Environment, Planning and  
Sustainable Development

DEVELOPMENT APPLICATION NUMBER: 202443505		
UNIT/S:	BLOCK/S: 22	SECTION/S: 56
SUBURB: YARRALUMLA		DISTRICT: CANBERRA CENTRAL

**Yarralumla Residents Association Submission DA 202443505**

**Figure 1 – Location of proposed Development within Yarralumla and Zoning**

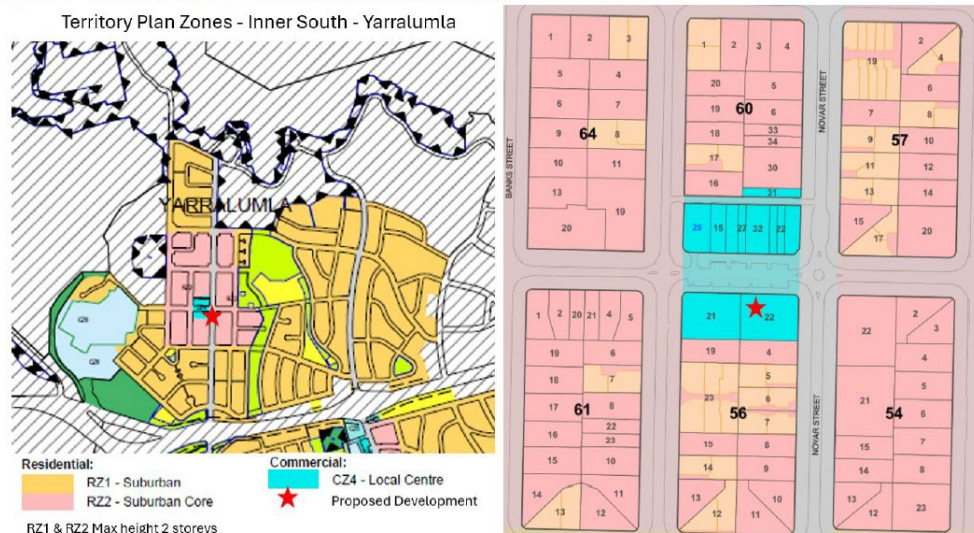
The scale of the proposed Development of 5 storeys, in effect 6 storeys owing to Lift Towers and Mechanical Venting on the roof, is not appropriate to the site or zone CZ4. The Commercial Zones Policy for CZ4 Local Centre Zone has a maximum building height of 2 storeys (Figure 1).

The scale of the proposed Development of 5 storeys is not appropriate to the site or zone - CZ4 Local Centre which sets a maximum building height of 2 storeys (Figure 1).

Figure 2- PLAN shows 14 of 16 Garbage Bins for 14 Multi Use Residential Development Units collected on nature strip of 39 Novar Street a Single Storey Residence taking up more two thirds of the area

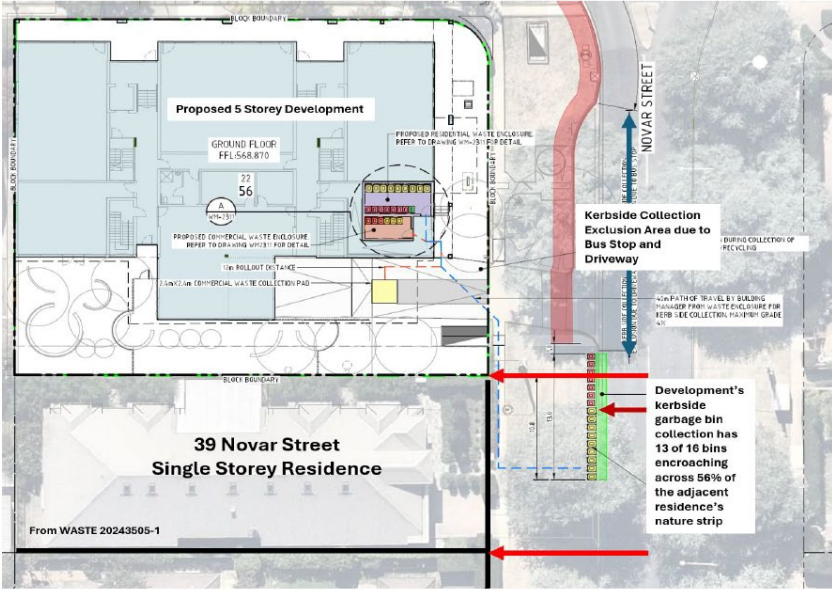
Kerbside waste collection of 14 of the multi residential unit bins is NOT located on the Site's kerbside BUT on the adjacent property at 39 Novar Street impacting on the property's amenity and responsibility to maintain the nature strip (Figure 2 and Figure 3).

If the garbage compound is not enlarged then the only place for the Hoppers to be stored and emptied is on the neighbour's nature strip alongside the site's residential units garbage bins (Figure 2).

Figure 6-Street View - Commercial Garbage Trucks turn in Bus Stop Bay and block Basement carpark access

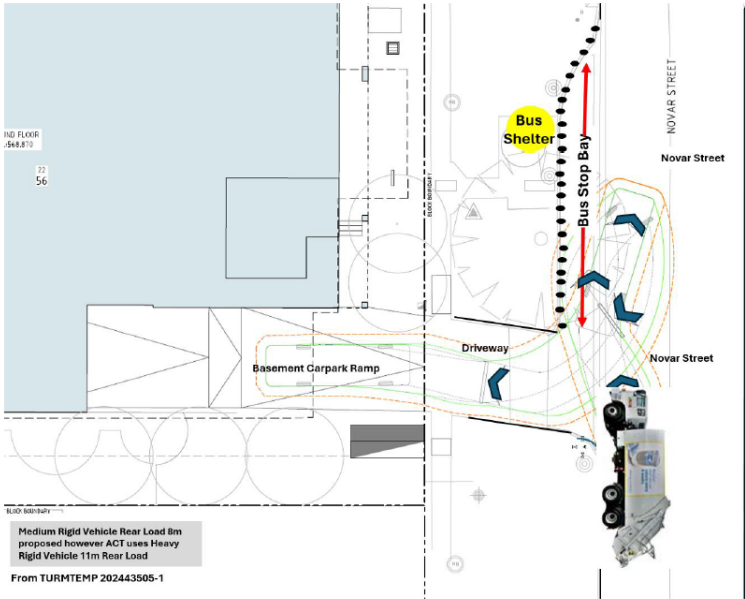
This underestimate of waste generation has consequences (Figure 5, Figure 6 and Figure 7):

A consequence of the use of Hoppers, is the need for the much larger 12.5 metre Garbage Truck with front loading which will have to enter the ramp in a forwards direction and reverse out into the Bus Stop Bay next to the roundabout on Novar Street (Figure 9). In addition the large Hoppers will need to be manhandled into place and be on flat ground. The current size of the commercial garbage bin compound is too small to accommodate the required number of bins and the large hoppers will not fit through the entry (Figure 7). If the garbage compound is not enlarged then the only place for the Hoppers is on the neighbour's nature strip alongside the site's residential units garbage bins. This is not an acceptable outcome.

Figure 7 – Development's Waste Storage Area

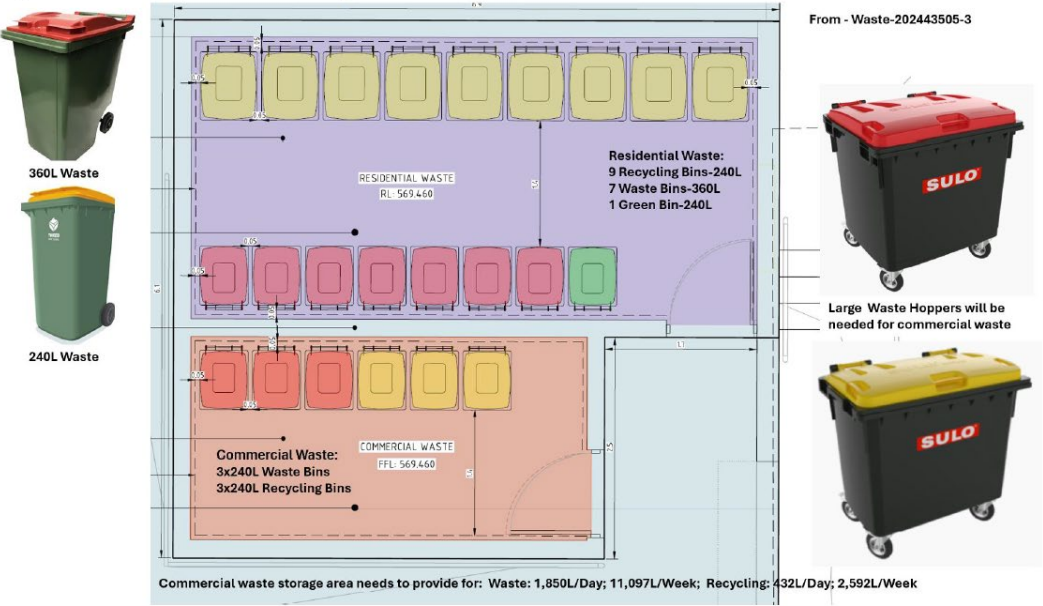
Commercial waste volumes are NOT based on the site's Restaurant/Retail uses but on "Office space" (DA Response -*Commercial Zones Specifications Assessment Outcome 5*) (Figure 4). Waste generation for an Office is 20L/100m<sup>2</sup> GFA/Day whereas a Restaurant/Café is 660L/100m<sup>2</sup> GFA/Day and a Shop is 50L/100m<sup>2</sup> GFA/Day. That is the waste generated will be a total of 1,849L/day and 11,097L/week, not 81L/Day and 486L/week. The waste generated is thus underestimated by a factor of 29. Currently only three 240L waste bins are provided with emptying once per week. This has consequences requiring upsizing to 3 large hoppers with daily emptying, a much larger commercial waste storage compound, a 12.5 metre forward entry Heavy Rigid Vehicle Garbage truck, and a flat collection point. The current proposal has 3x 240L bins emptied once per week (Figure 4 and Figure 7).

Figure 8 - Demolition (from Sediment Control Plan)

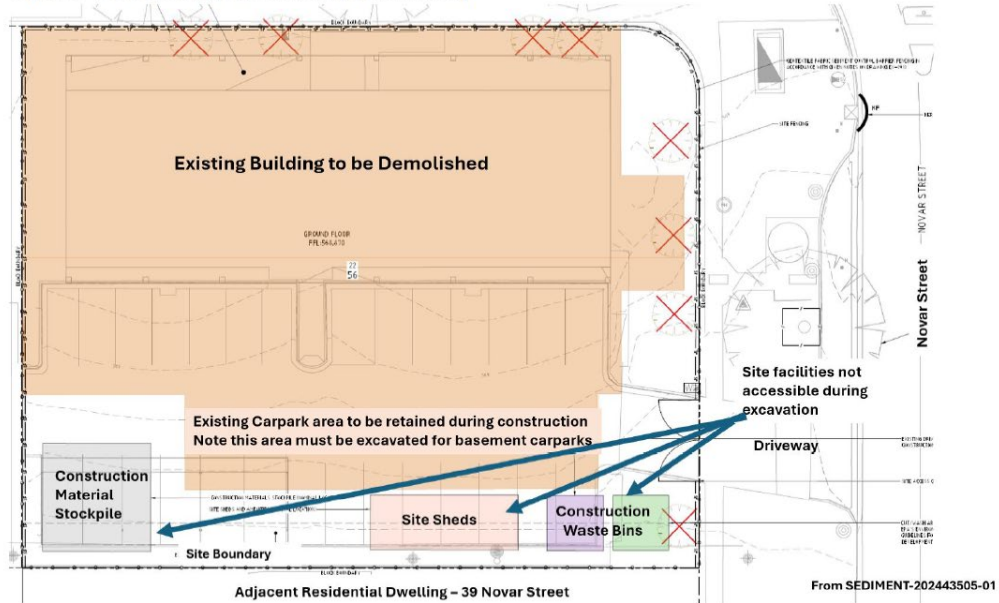
It is not possible for demolition and construction activities and materials to be managed on site. It is not possible, as proposed, to retain the existing carpark area and use it for access to stockpile materials, site sheds and construction waste, whilst at the same time excavating the area for basement carparks (Figure 8).

The Plan SEDIMENT- 202443505-1 identifies that the existing carpark area is to be retained during construction, and the construction materials stockpile, construction waste bins and site sheds and amenities are located against the boundary of the 39 Novar Street residence with their associated dust noise and constant activity (Figure 8).

The proposed Development requires not only the demolition of the two storey office building and carpark but also the excavation of 85% of the site for the construction of the two levels of basement carparks and access ramps. Thus it is not possible to retain the existing carpark area and use for access to stockpile materials, site sheds and construction waste whilst at the same time excavating it for basement carparks (Figure 8).

**From FLOORREG-202443505-GROUND-03 Shows 12 metre roll out path for waste hoppers but requirement is that it should not exceed 4 metres**

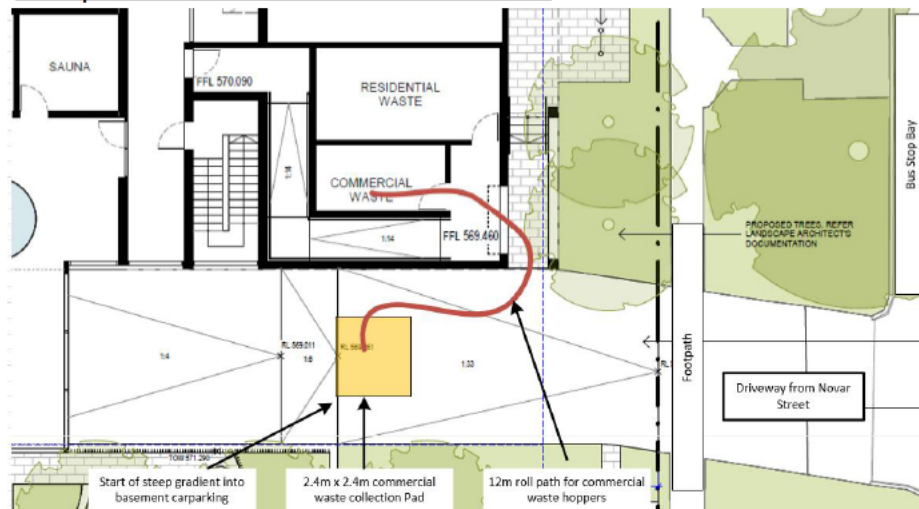
The DCC for Best Practice Waste Management states "*maximum hopper roll-out distance from the roller door entrance to the designated collection point must not exceed 4m*", the DA document WASTE-202443505-01, show the roll-out distance as 12m. Thus the proposed development does not comply with this mandatory requirement.

The developments design and approach to commercial waste management is non-compliant with mandatory requirements, is seriously under specified for the volume of commercial waste to be collected and poses WHS and safety hazards both on site and to pedestrians, bus commuters and road users.

**From WASTE-202443505-1 – Proposed kerbside collection zone on neighbouring property showing location of overhead power lines**

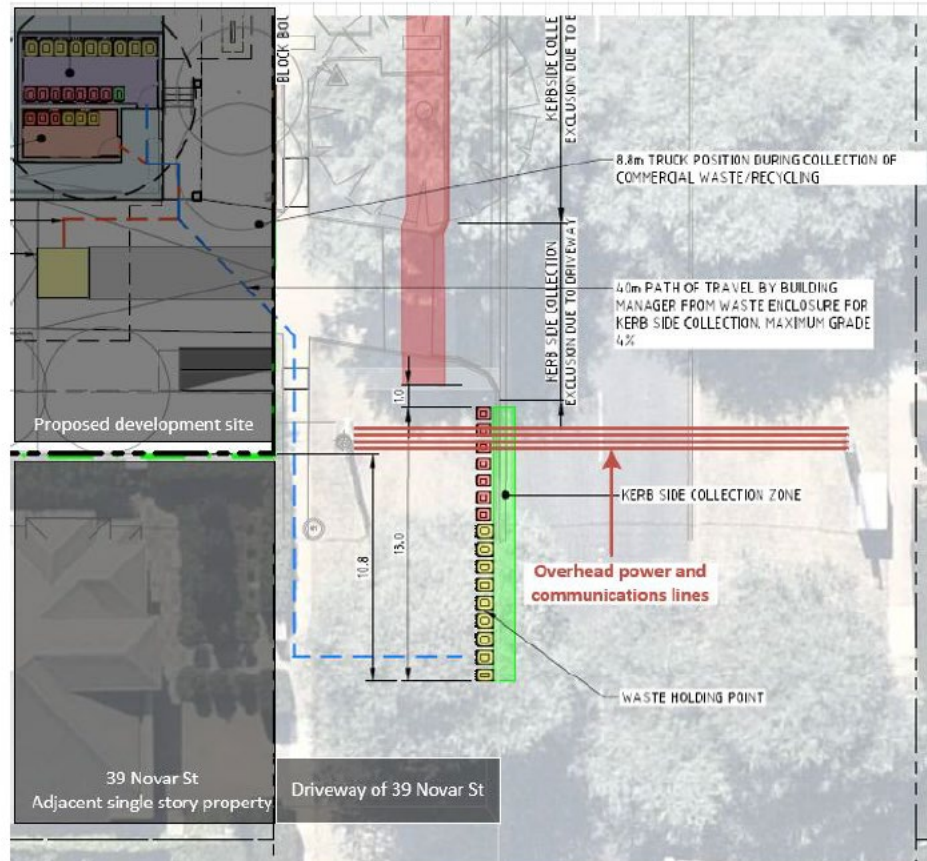
The proposed residential kerbside waste collection is non-compliant with the DCC for Best Practice Waste Management and has an unacceptable impact on the residence at 39 Novar Street and its nature strip frontage.

Development site frontage for kerbside collection of residential waste is not possible. The northern frontage of the development on Bentham Street has exclusions because of the on-street parking, and the eastern street frontage on Novar Street is fully excluded because of the bus stop bay, driveway and powerlines lines. Thus the development proposes to have the kerbside collection point for the 16 garbage bins on the nature strip of the adjoining residential property 39 Novar Street in contravention of the mandatory requirements of the DCC for Best Practice Waste Management.

Furthermore the proposed kerbside collection zone in front of 39 Novar Street is under power and communications lines, is obstructed by road signage and the Heritage listed Street Tree which is a Registered Trees (Tree Number PTR090-Group). Kerbside collection is not allowed under power lines. The ACT tree register identifies and protects trees of exceptional value on private and public land. Registered trees must be protected in accordance with the *Urban Forest Act 2023*. The registered tree thus reduces the area for kerb side collection, there is not sufficient space on the 39 Novar Street's nature strip for the 16 residential bins from the proposed development.

**Street View of proposed kerb side collection zone for residential waste on the nature strip of 39 Novar Street showing powerlines, road sign and registered trees**

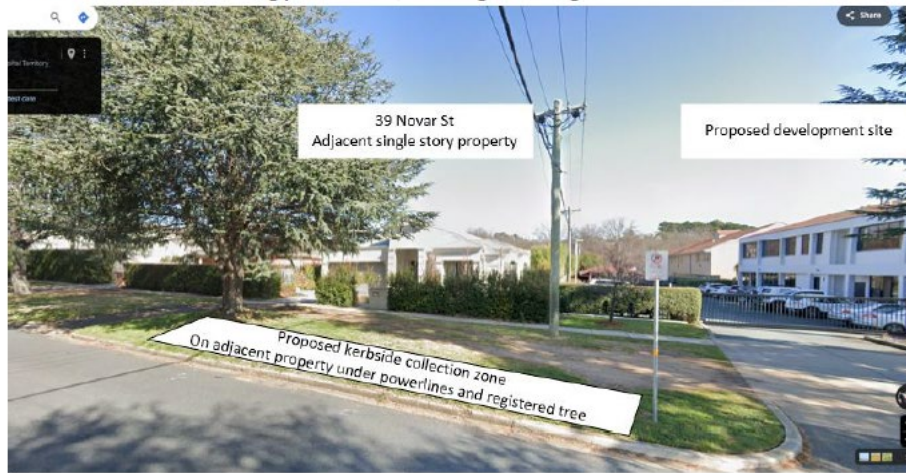
The developments approach to residential waste collection is non-compliant with mandatory requirements and has an unacceptable impact on the single residence at 39 Novar Street.

**Street View of driveway on Novar Street with adjacent bus bay and Registered Tree**

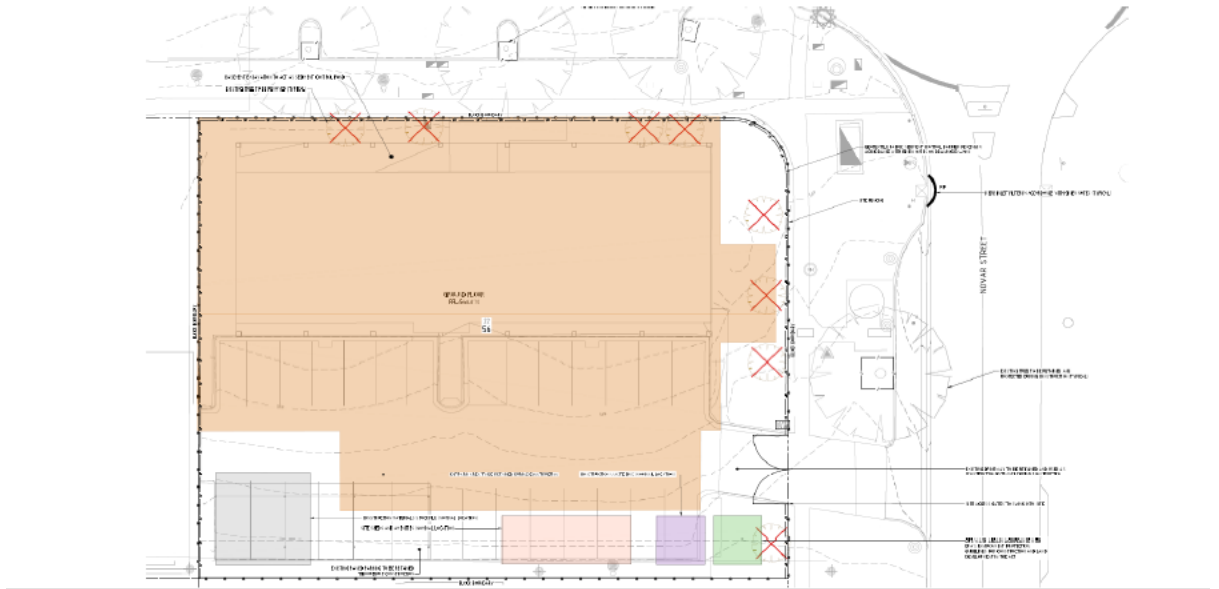
This limited street access and the scale and location of the area to be excavated for the two levels of basement car parks presents huge physical and logistical problems for managing all the demolition and construction works on-site.

**From SEDIMENT-202343505-01 – The area to excavated is shaded brown, around 85% of site**

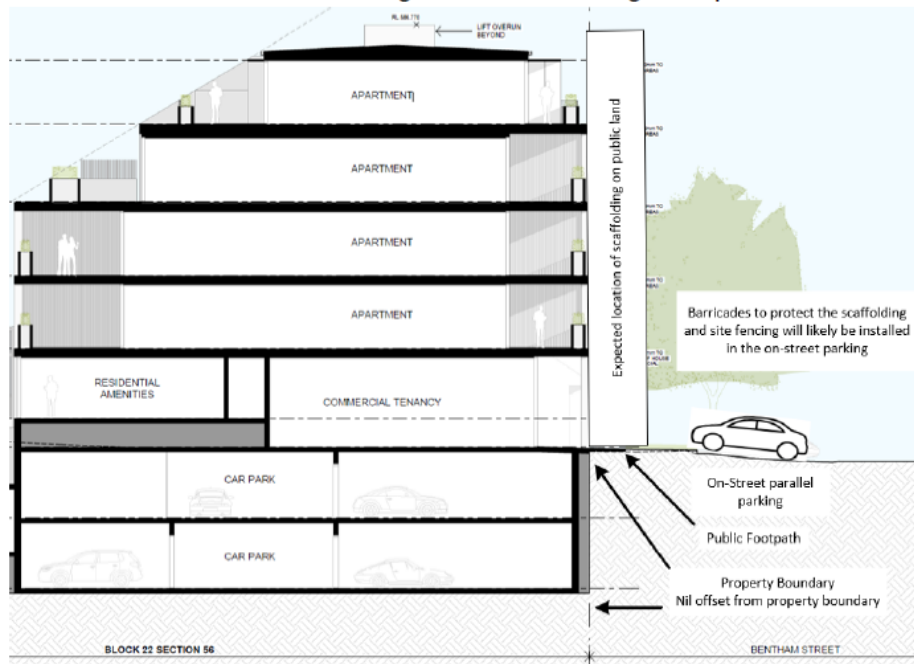
The proposed approach to excavation of the site and construction of the 5 storey building with two levels of basement parking is not viable. The DA document SEDIMENT-202343505-01 and the Floor Plans of the basement levels show that the around 85% of the site will be excavated for the two basement levels. The proposed location of the site sheds and amenities will be on the edge of a 6 metre deep excavation and will be difficult to safely access. Vehicle access to the proposed "Construction Material Stockpile" will not be possible once the excavation of the basement is started. The SEDIMENT-202343505-01 document states "*Carpark area to be retained during construction*", this is not possible as the area will be excavated for the basement levels.
